# **DEVELOPMENT APPLICATION ASSESSMENT REPORT**

Application Number:	DA2021/2229		
Responsible Officer:	Stephanie Gelder		
Land to be developed (Address):	Lot 17 DP 206006, 23 Courtley Road BEACON HILL NSW 2100		
Proposed Development:	Alterations and additions to a dwelling house		
Zoning:	Warringah LEP2011 - Land zoned R2 Low Density Residential		
Development Permissible:	Yes		
Existing Use Rights:	No		
Consent Authority:	Northern Beaches Council		
Land and Environment Court Action:	No		
Owner:	Scott John Price Kate Sarah Price		
Applicant:	Kate Sarah Price		
Application Lodged:	14/01/2022		
Integrated Development:	No		
Designated Development:	No		
State Reporting Category:	Residential - Alterations and additions

Figure 1. North Elevation

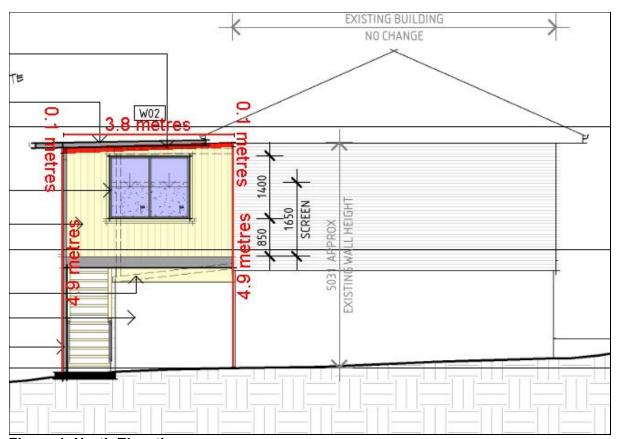
The proposal is sited outside of the building envelope on the north and south elevation as depicted in Figure 1 and Figure 2. The northern façade obtains a minor encroachment outside of the building envelope for 0.1m metres in height for a horizontal length of 3.8 metres, resulting in a variation of 2.04%. The southern façade encroaches outside of the building envelope for 0.8 metres in height for a horizontal length of 3.8m, resulting in a variation of 16.33%.

In this instance, whilst the encroachment of the building envelope control is numerically non-compliant, the proposal demonstrates compliance with the objectives of the control as outlined below. Therefore, the variation to the building envelope control is considered to be supportable.
